**Analysis of the Final Feasibility Study and Environmental  
Impact Assessment for the Proposed Chalillo Dam**

**Prepared for The Belize Alliance of Conservation Non-Government  
Organizations**

**Conservation Strategy Fund**

February 2000

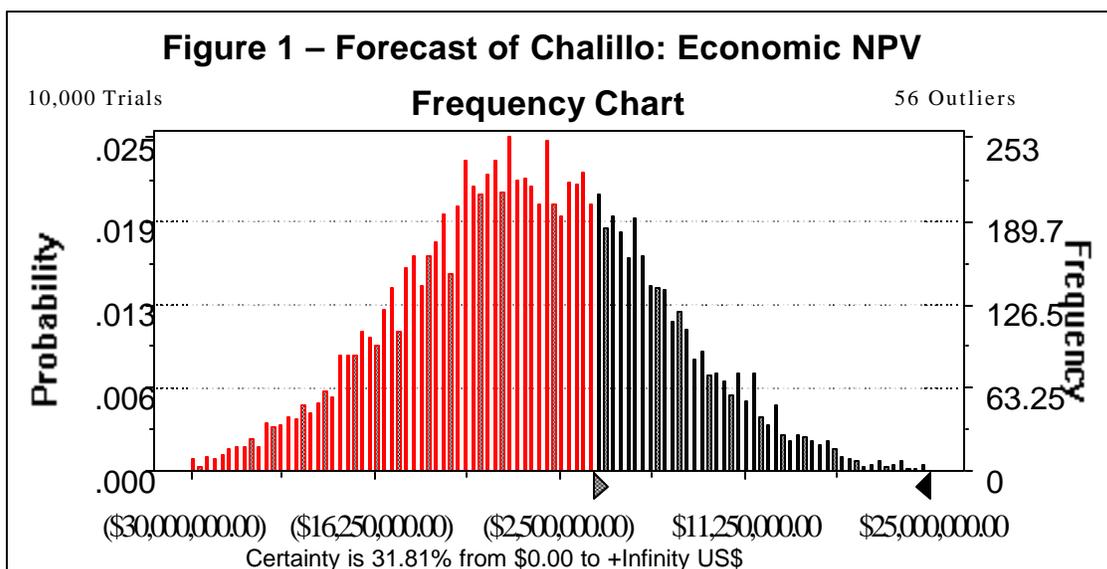
Risk analysis is the tool for measuring this probability. In this analysis we specify a range of likely values for some of the more important variables. Probability distributions are assigned around the mean values for each variable. Risk software generates different combinations of these values and shows the range of possible NPVs. We ran 10,000 combinations of the variables in order to arrive at this range of possible NPVs.

The risk analysis chart above indicates that there is a 32 percent chance that the project will be economically viable, before counting any external costs. The mean NPV in the risk analysis is -\$4.47 million. We artificially assume a normal distribution for power production. The actual distribution would be truncated on the upper end, since the design flow imposes a limit on how much power can be produced. That means our assumption overestimates the NPV. We have also assume a normal distribution for construction costs, with an equal possibility of cost savings and cost overruns, despite the fact that the typical hydroelectric dam project in developing country goes 27 percent over budget (Bacon et al. 1996). An overrun of this size would drive Chalillo's NPV to less than -\$12 million. This sort of miscalculation becomes less likely as the Chalillo site and design are studied in more detail.

**Figure 2 - Belize Peak Demand**

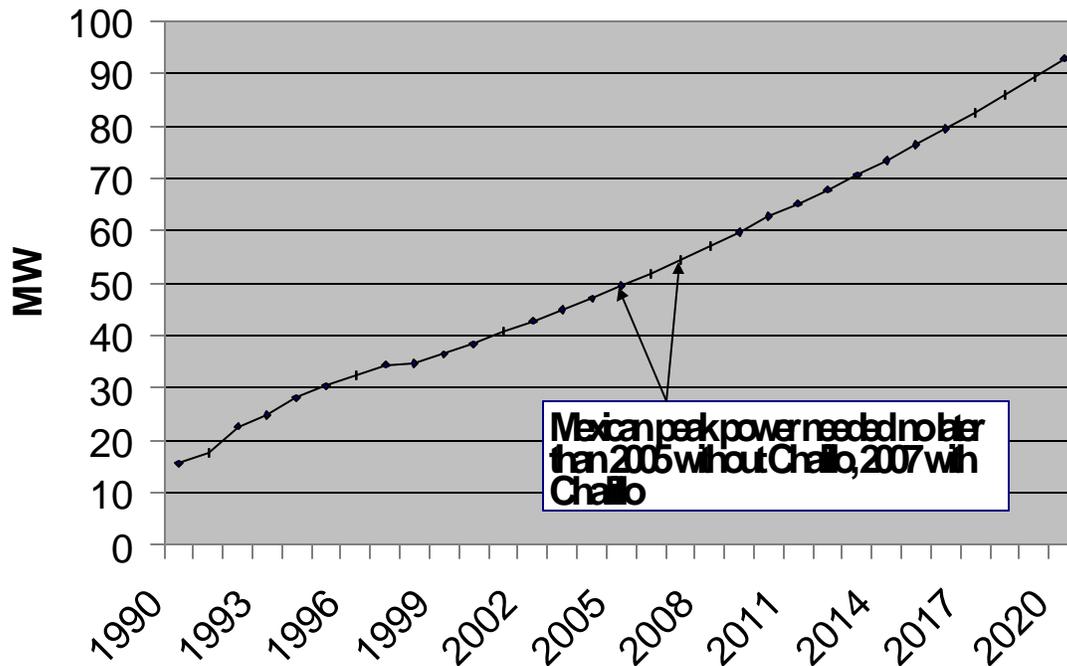
According to BEL, the utility has 30 MW of interconnected diesel capacity, and 4 MW of isolated diesels ([www.bel.com.bz](http://www.bel.com.bz), February 10, 2000), in addition to the 21.3 MW firm capacity at Mollejon. Peak demand is estimated at around 35 MW. If the diesels could operate at 80 percent of capacity during peak periods, Belize could conceivably do without Mexican peak power until the year 2005. With Chalillo, Belize would be compelled to buy some Mexican peak power no later than 2007. Chalillo delays the need for Mexican peak power by two years. This timing is based on peak demand growth of 4.9 percent over the next ten years and 4 percent thereafter, as projected by the World Bank (1994). BEL projects a 6.5 percent rate for the coming years. (Lynn Young, Joseph Sukhndan, personal communication, July 1999). Using that rate, the absolute need for

Mexican peak power would occur a year earlier – no later than 2004 without Chalillo and 2006 with the project.
